ENGLEWOOD
HOSPITAL AND MEDICAL CENTER

RE: NRC license No. 29-08519-01

PET/CT UNIT 3-8-06

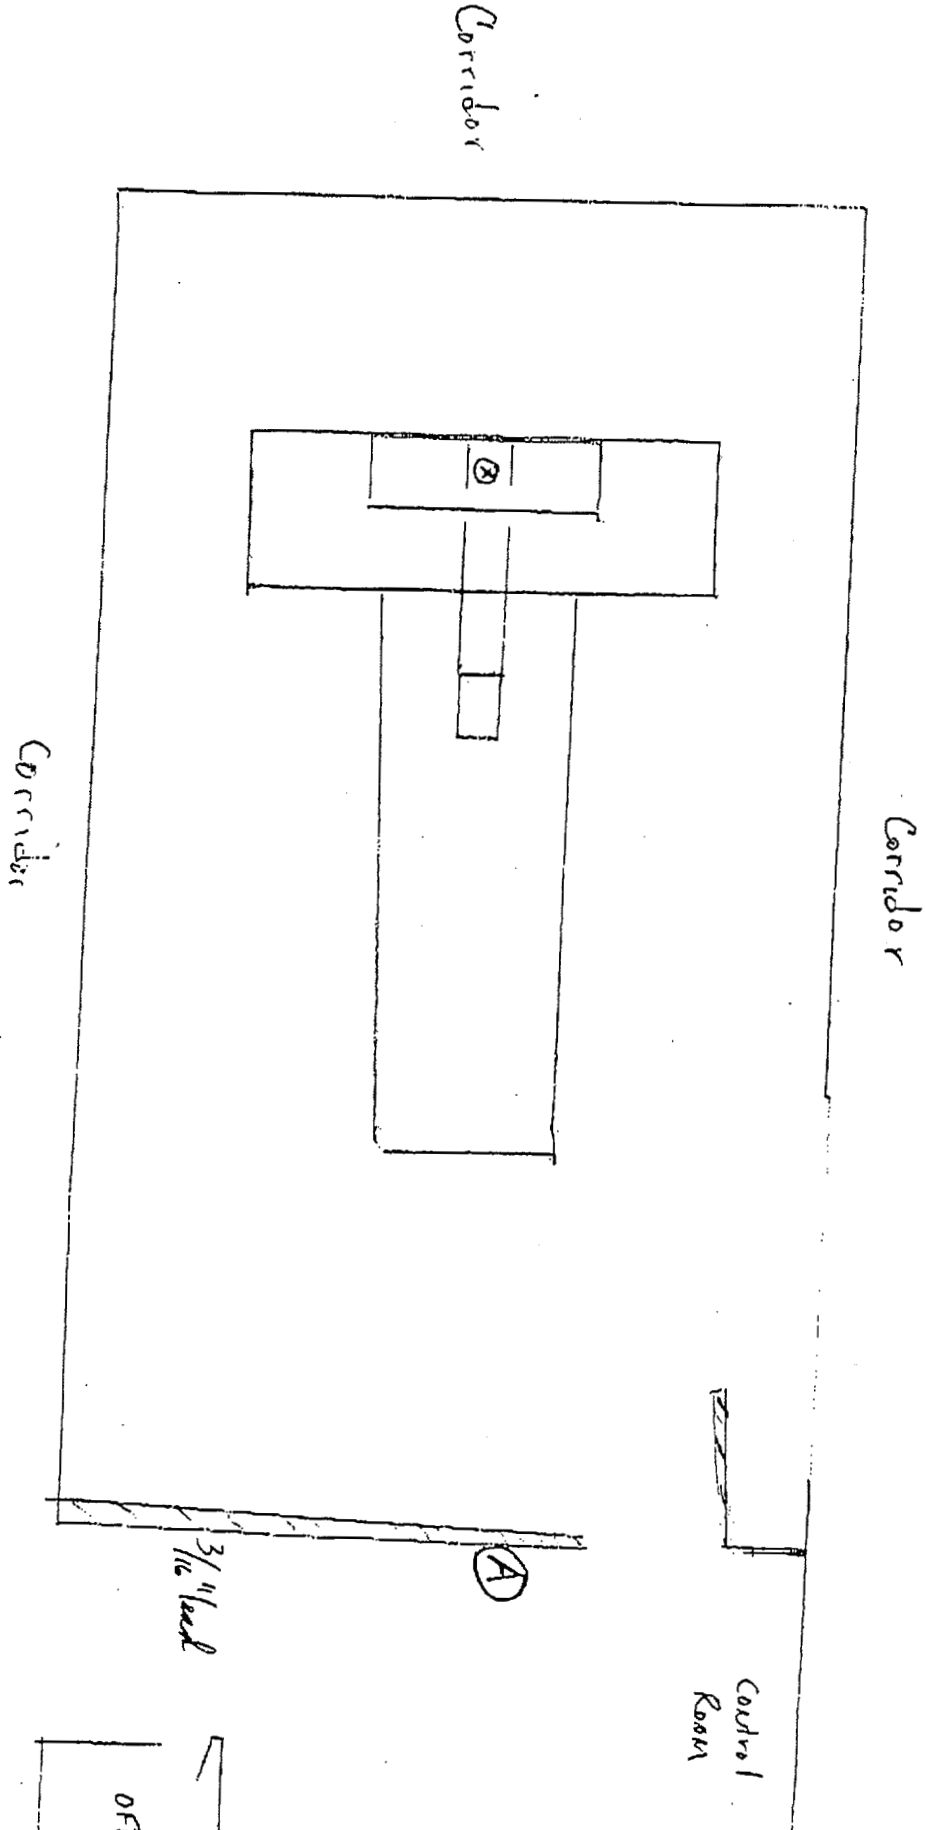
This letter addresses the questions that you presented to Mr. Joe Sudano on 3/6/06 regarding our amendment request dated January 18, 2006. I have enclosed a drawing which shows the PET/CT room, barrier A will be removed and replaced with a 3/16 inch lead barrier and door.

Barrier A is being removed
and replaced with a 3/16"
lead barrier on floor
